FCC Class II Permissive Change Request Letter

RE: FCC Permissive II Change Request for Company: ION Audio, LLC FCC ID: 2AB3E-IPA174

| Serial number | Original | New |
|---------------|-------------------------------------------------------------------------------------|--------------------------------------------------------------------------------------|
| 1 |  |  |

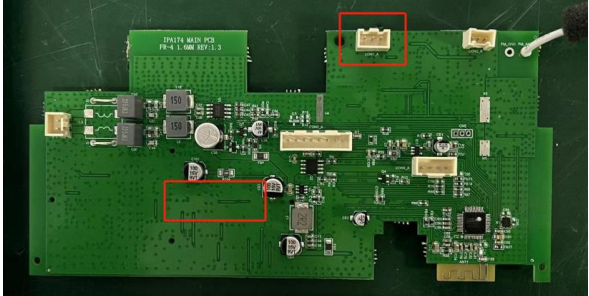
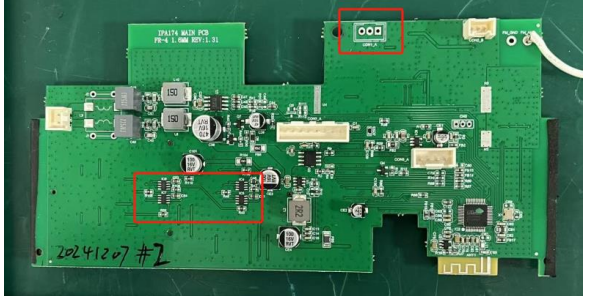
1. Added new models TRAILBLAZER® SUMMIT, iPA174A, TRAILBLAZER***** and iPA174A***** (“*” can be “a-z”, “A-Z”, “0-9”, blank, “-”, “+” or any character, symbol, alphanumeric).
2. Change product name.
3. Change LED, LED driver IC and peripheral circuit components.
4. Change the USB input/output board.
5. Remove MIC input function, remove input ports and input components related to MIC function (capacitors, ic, etc.).
6. The battery capacity is reduced from 2600mAh to 2000mAh.
